APPLICATION NO.	FILING DATE	FIRST NAMED INVENTOR	ATTORNEY DOCKET NO.	CONFIRMATION NO.
10/782,277	02/19/2004	Jack E. Caveney	LCB416	4229
32915	7590	11/16/2007	EXAMINER	
PANDUIT CORP. LEGAL DEPARTMENT - TP12 17301 SOUTH RIDGELAND AVENUE TINLEY PARK, IL 60477			WOOD, KIMBERLY T	
		ART UNIT	PAPER NUMBER	
		3632		
		MAIL DATE	DELIVERY MODE	
		11/16/2007	PAPER

Office Action Summary	Application No.	Applicant(s)
	10/782,277	CAVENEY ET AL.
	Examiner Kimberly T. Wood	Art Unit 3632

This is an office action for serial number 10/782,277.

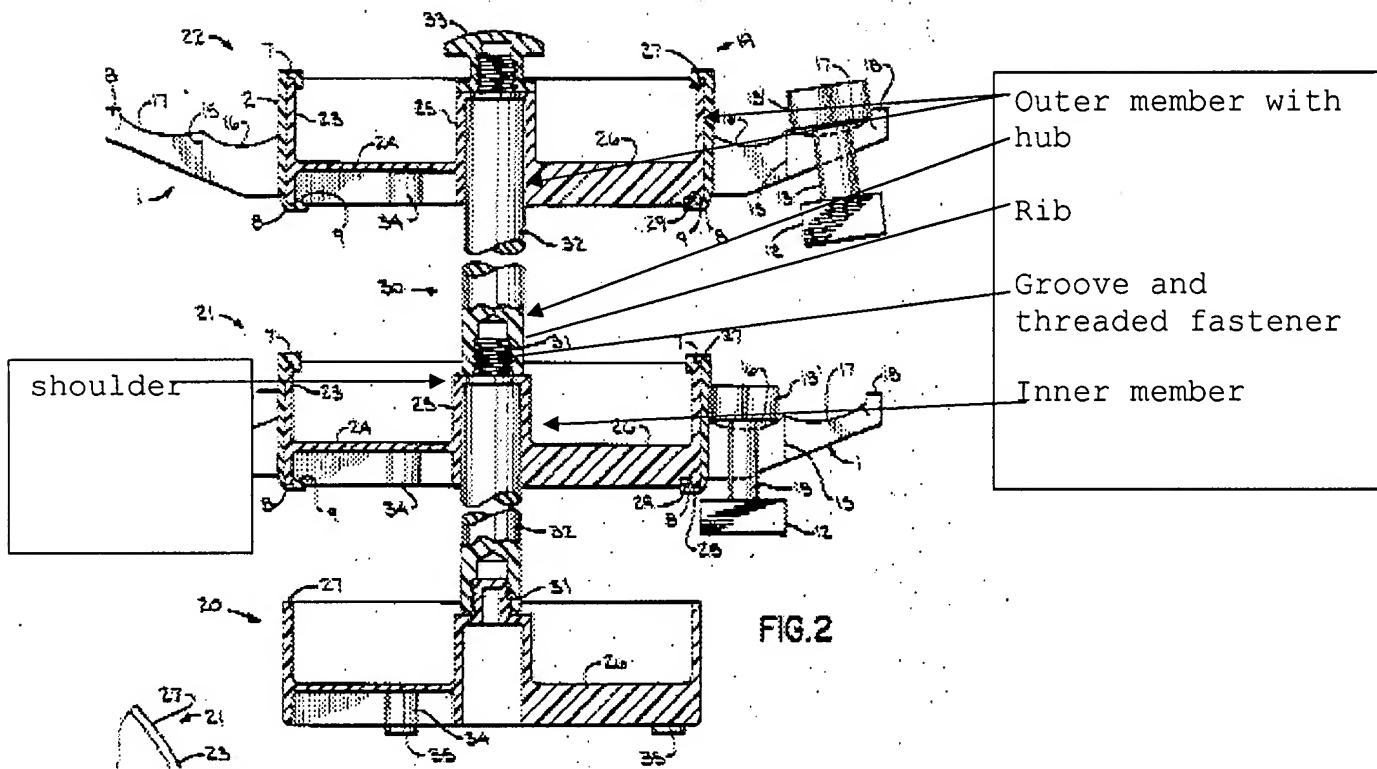
Claims 1-3 and 25-27 are rejected under 35 U.S.C. 102(b) as being anticipated by Zahn et al. (Zahn) 4,534,471 in view of Collins et al. (Collins) 6,613,053. Zahn discloses an outer member having a rib (interior threads include ribs) and a hub, an inner member having a groove along an exterior surface (exterior threads includes a groove) and a threaded fastener, a plurality of rungs (26). Zahn discloses all of the limitations of the claimed invention except for the snap fit connection and

the at least 4 rungs. Maas discloses a coupling means being a snap fit connection (31 rib and 30 groove). It would have been obvious to one having ordinary skill in the art to have modified to have included the snap fit connection as taught by Collins for the purpose of providing a quick release connection or a more secure means. It would have been obvious to have made at least four rungs since duplicating the components of a prior art device is a design consideration within the skill of the art.
